**Overview:** Production error in version 1.0 harnesses; The immobilizer wire (orange/black) is in pin position #4 instead of pin position #5. Although an effort to correct the issue was made, some quantity of harnesses did get shipped before the issue was spotted. We are advising to inspect the harness BLADE connector before attempting to install harness or program the module. This issue is not known to affect the version 2 harnesses, which require no modification.

**Overview:** Early versions of the FTI-STP1 harness require modification for **automatic transmission (AT)** applications, some of the product was able to be modified before release, but a small quantity was released without modification.

## FTI-STP1: Installation and Configuration Notes

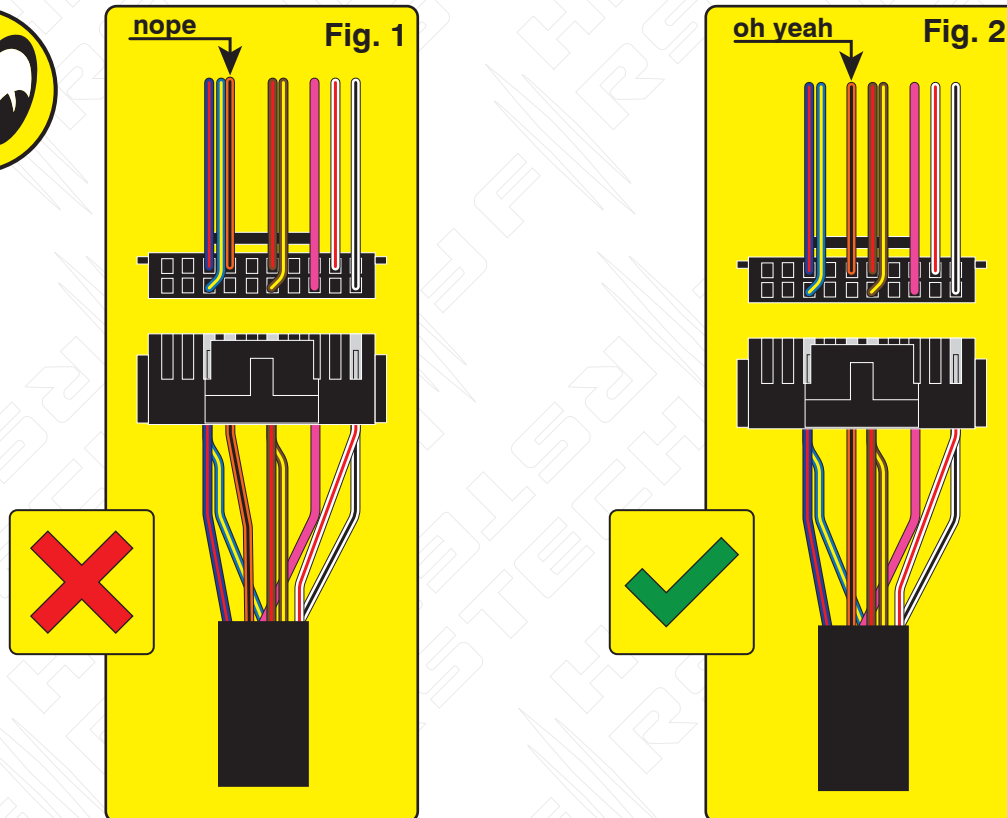
**Issue:** Module fails to program correctly to vehicle, does not allow the vehicle to be remote started.

**Correction:** Step 1.) Locate the orange/black wire and confirm whether it is positioned as illustrated in Fig. 1 or Fig. 2. If the wire is as illustrated in Fig.1, proceed with Step 2 through 5 and complete the repair procedure outlined, if the wire is as illustrated in Fig. 2, correction is not necessary, proceed with harness installation and module programming.

**Step 4.)** Refer to Fig. 2 for correct position of the orange/black wire (next to brown/red) then reinsert the terminal, pressing lightly until the catch 'snaps' into place, securing the terminal in the connector housing.

**Step 2.)** Using a pick, lightly depress the catch that secures the terminal in the housing then remove the wire and terminal from the housing.

**Step 3.)** Using a fine tip razor or utility knife, insert the blade beneath the terminal catch and raise it slightly, so that it can be reused to secure the terminal when reinserted into the BLADE connector housing.

**Step 5.)** The repair is complete, proceed with installation and programming.

**MODIFICATION REQUIRED FOR A/T APPLICATIONS, ONLY WITH v 1.0 HARNESS**

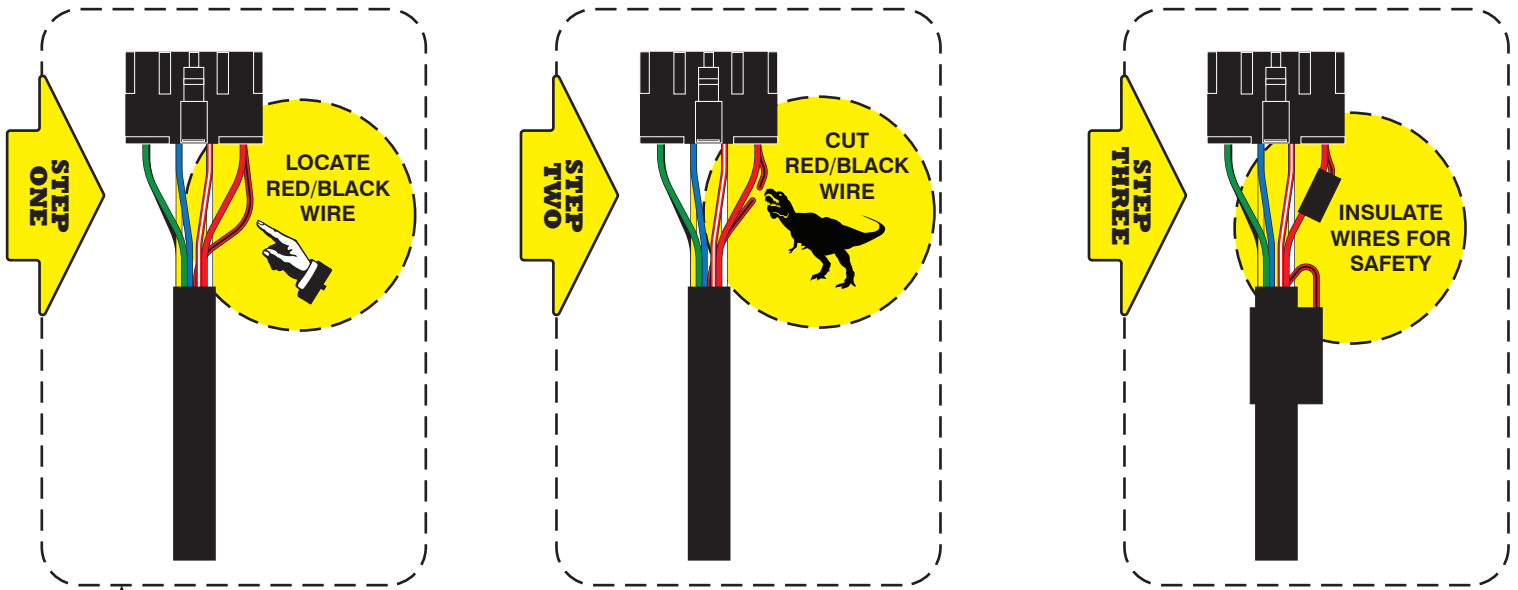
**Issue:** The FTI-STP1 T-harness has been designed to be compatible with A/T (automatic transmission) & M/T (manual transmission) applications, but due to an oversight in early production runs, the selection was defaulted to M/T mode.

Using a harness configured for an M/T application, in an A/T equipped vehicle, could result in vehicle module damage, it is advised that the harness be returned to A/T mode before installation in vehicles equipped with an automatic transmission.

**MODIFICATION NOT REQUIRED WHEN USING FTI-STP1 (v 1.0) HARNESS IN M/T APPLICATIONS, OR WHEN USING THE FTI-STP1 (v 2.0) HARNESS**

**Correction:** Locate the **red/black (+ Clutch)** wire provided in the CN1 connector of the main harness assembly. Cut the **red/black** wire, either flush to the CN1 connector, or leaving enough wire exposed so that you can insulate and secure the ends of the wire that remain after cutting. Insulate each of the remaining ends of the **red/black** wire and secure to prevent any possibility of a short circuit. **If the red/black wire has already been disconnected, no further modification is required for A/T applications**

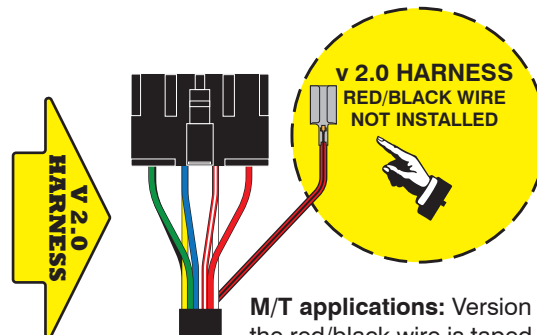
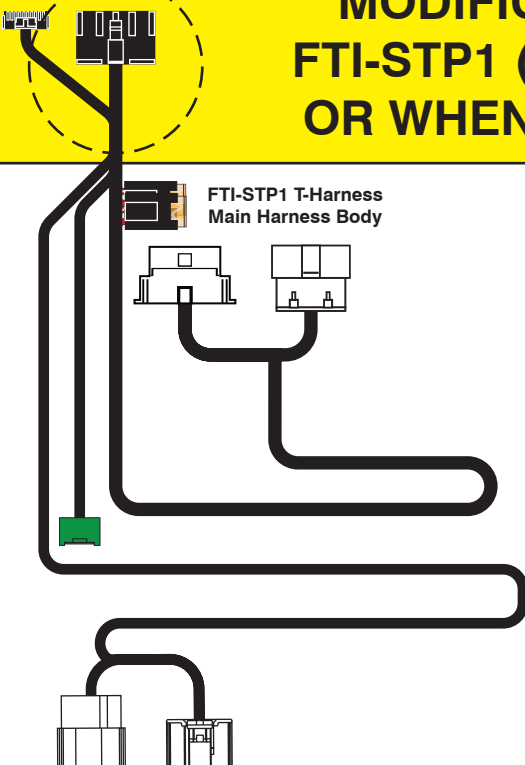
**M/T applications:** Version 2.0 harness, the red/black wire is taped to the main harness when shipped, and must be installed in the CN1 connector when installed.

**A/T applications:** Leave the red/black wire taped to the harness, it is not required for A/T applications
